**BID
ADDENDUM NO. 2
TO
CONTRACT DOCUMENTS
AND
TECHNICAL SPECIFICATIONS
FOR
NEW MAINTENANCE GARAGE
AT
825 WEST LAKE DRIVE
THORNWOOD, NY 10594
NYS ED #66-08-01-06-3-012-001**

Mount Pleasant Central School District
825 West Lake Drive
Thornwood, NY 10594

LAN Job #4.1449.02
February 9, 2022

E5.01

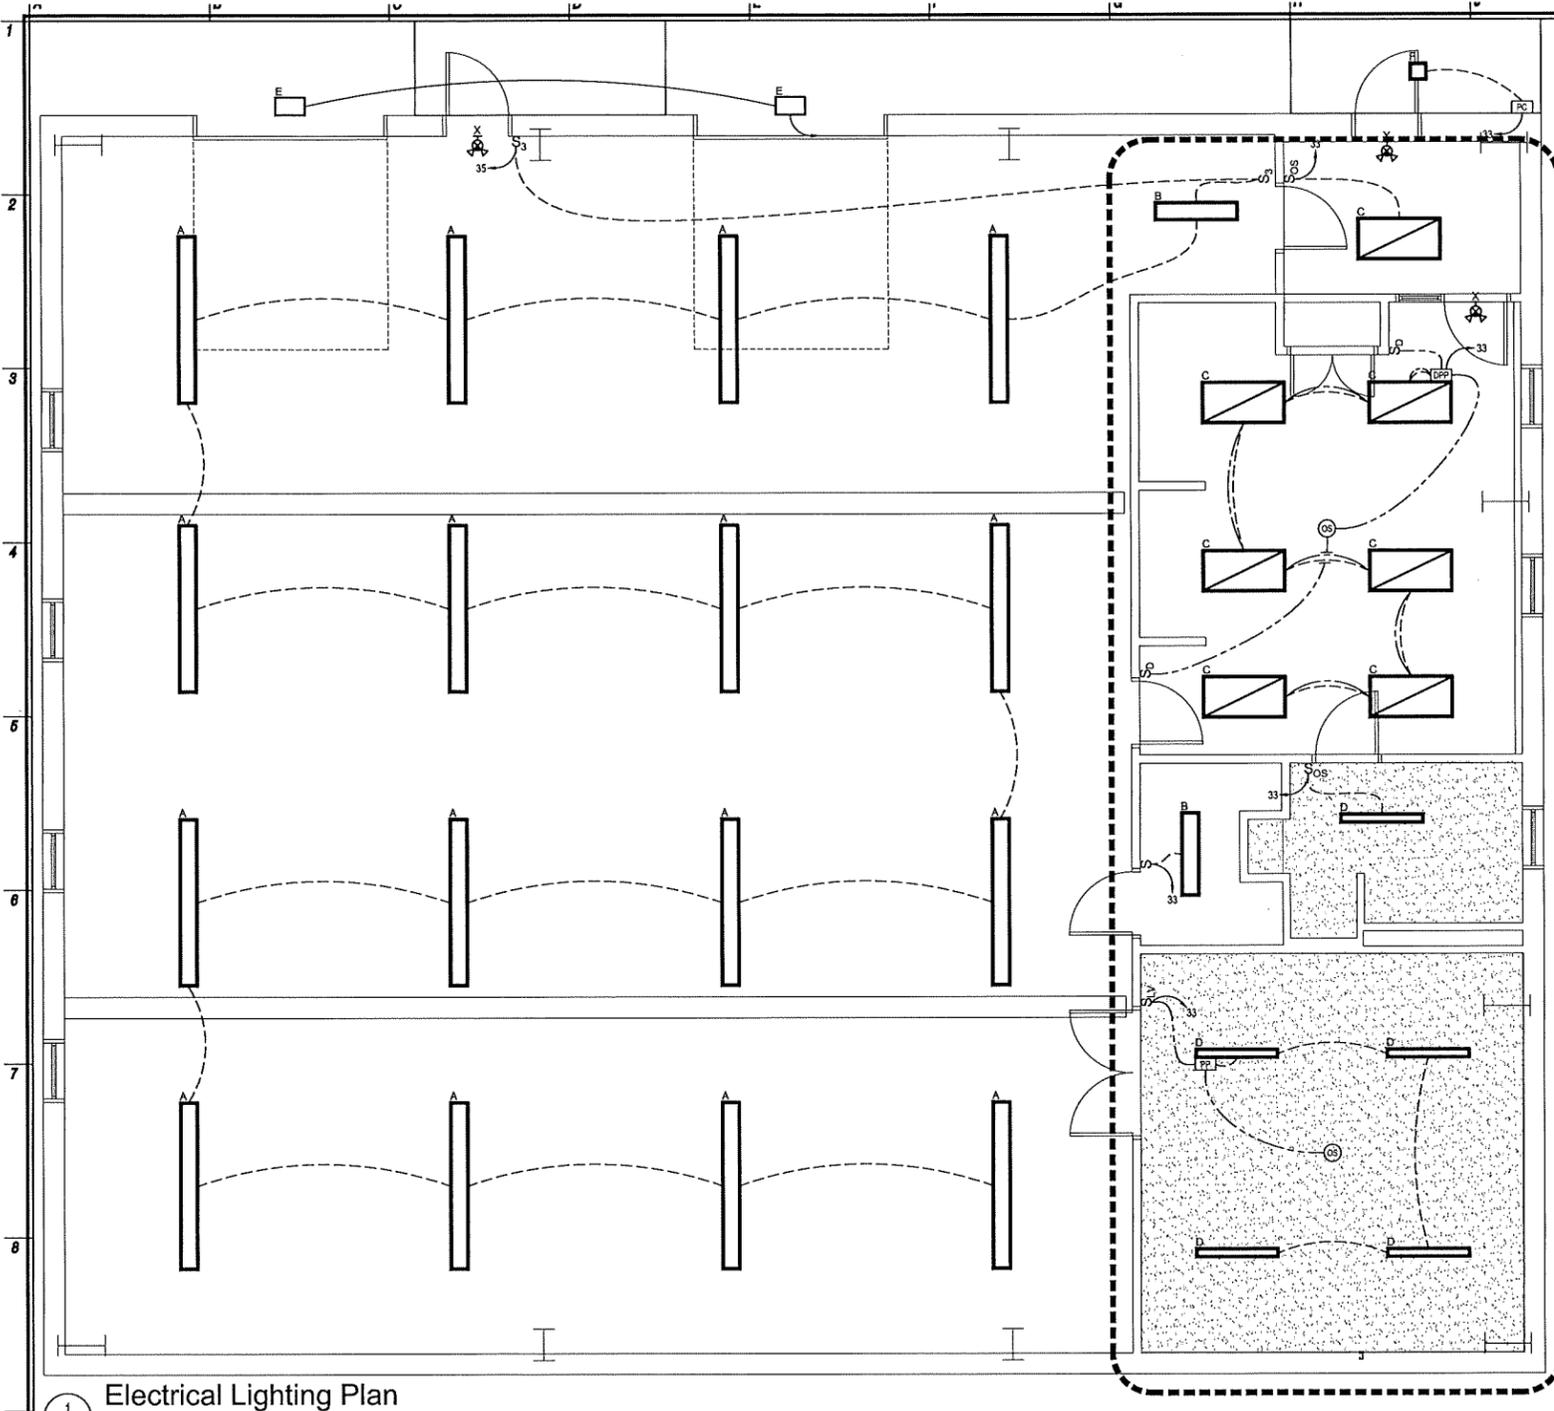
No.	Comment / Response
1	<p>Comment: On Drawing No. E5.01 no emergency lighting is shown or indicated in the light fixture schedule. Please confirm the same is not required.</p> <p>Response: Please see attached for revised sheet E5.01.</p>
2	<p>Comment: On Drawing No. E5.01 no exit signs are shown or indicated in the light fixture schedule. Please confirm the same is not required.</p> <p>Response: Please see attached for revised sheet E5.01.</p>
3	<p>Comment: On Drawing No. E5.01 if Add Alternate #3-1 is not accepted is there any light fixtures required for this area as part of the base bid? If so please advise on the type and quantity.</p> <p>Response: Base Bid shall include all Type 'A' fixtures, all Type 'E' fixtures, and all Type 'F' fixtures. Base Bid shall also include all related wiring, conduit, switches, and all labor for the above noted light fixtures.</p>
4	<p>Comment: On Drawing No. E2.01 please advise if ECH-1 and the carbon monoxide detector in Vestibule 01 should be apart of Add Alternate #3-1 or base bid.</p> <p>Response: ECH-1 and carbon monoxide detector are not included in the Base Bid. These items are to be included in Add Alternate 3-1.</p>

F	ACUITY LIGHTING	CNYLED P0 40K MOLT WH - CNYBCP		"CNYLED" LED CANOPYCEILING LUMINAIRE	UNV.	27	CLG. SURFACE	N/A	3500	130	80CRI, 40K	3
X	ACUITY LIGHTING	LH2MLED R		"QUANTUM" COMBINATION EXTREMURGENCY LIGHTING FIXTURE	UNV.	4	WALL SURFACE	12" ABOVE DOOR	N/A			4
